Exhibit 1.3

Milburnie Road Matrix of Required Retrofits to Covered Unit Interiors

MILBURNIE ROAD APARTMENTS: COVERED UNIT INTERIORS

Surveyed Unit 103, Building 2 and Unit 101, Building 6 – Typical for 16 total units

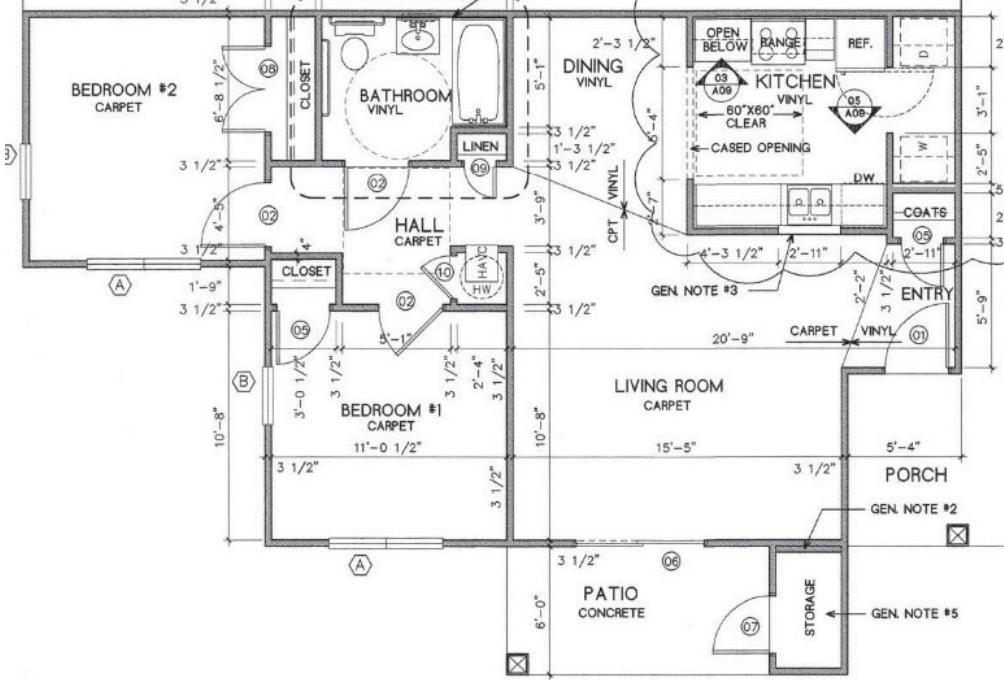
Numbers	Photos	Deficiency	Required Retrofit								
29	 <p>Patio door threshold at Unit 103, Building 2.</p>	<p>Door thresholds are more than 3/4 inch high and are not beveled (maximum 3/4 inch with bevel allowed).</p> <p>Height <u>Location</u> <u>(inches)</u></p>

Unit 103, Building 2	1-1/4	Patio interior side		Unit 101, Building 6 side	1-3/8	Unit 101, Building 6 exterior side	1-3/8	<p>Modify door thresholds to comply with Requirement 4(4).</p>
Unit 103, Building 2	1-1/4										
Patio interior side											
Unit 101, Building 6 side	1-3/8										
Unit 101, Building 6 exterior side	1-3/8
